SUPPLEMENTAL BID BULLETIN NO. 1

**SUPPLY OF LABOR AND MATERIALS FOR THE DESIGN, FABRICATION, DELIVERY
 AND ON-SITE INSTALLATION, TESTING AND COMMISSIONING OF EQUIPMENT AND
 MACHINERIES FOR COCONUT COIR AND PEAT PROCESSING CENTER
 (PHilMech-Goods-23-07-15)**

This **Supplemental/Bid Bulletin No. 1** is being issued to clarify, amend and supplement provisions in the Bidding Documents.

ANNEX A.

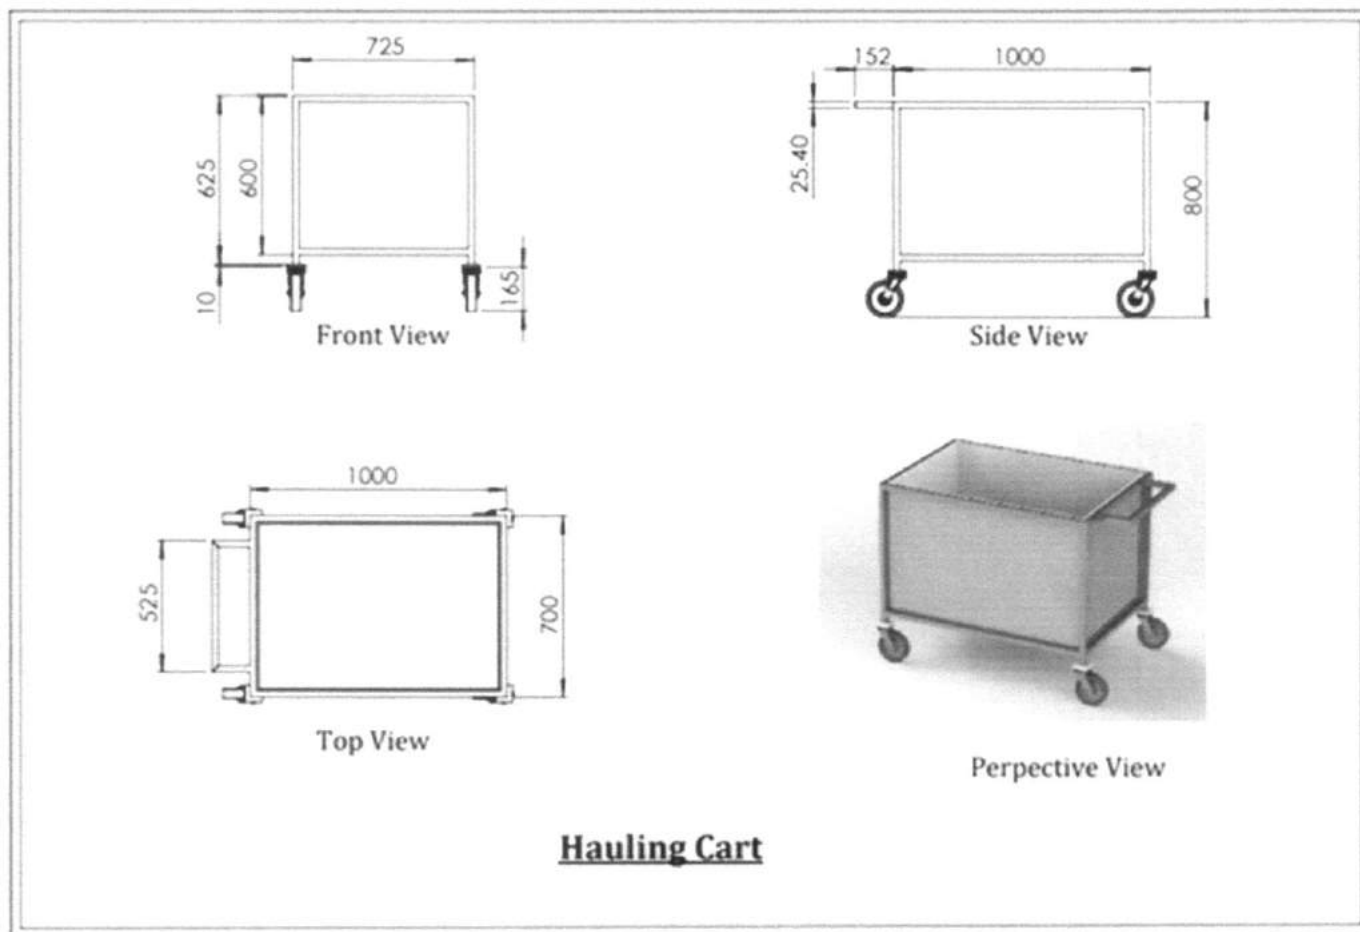
1. <i>Issue / Proposal: Request for the Hauling Cart's similar figure</i>		
<i>Action Taken/Reply: Request/proposal is granted. Similar figure is hereby attached as Annex A</i>
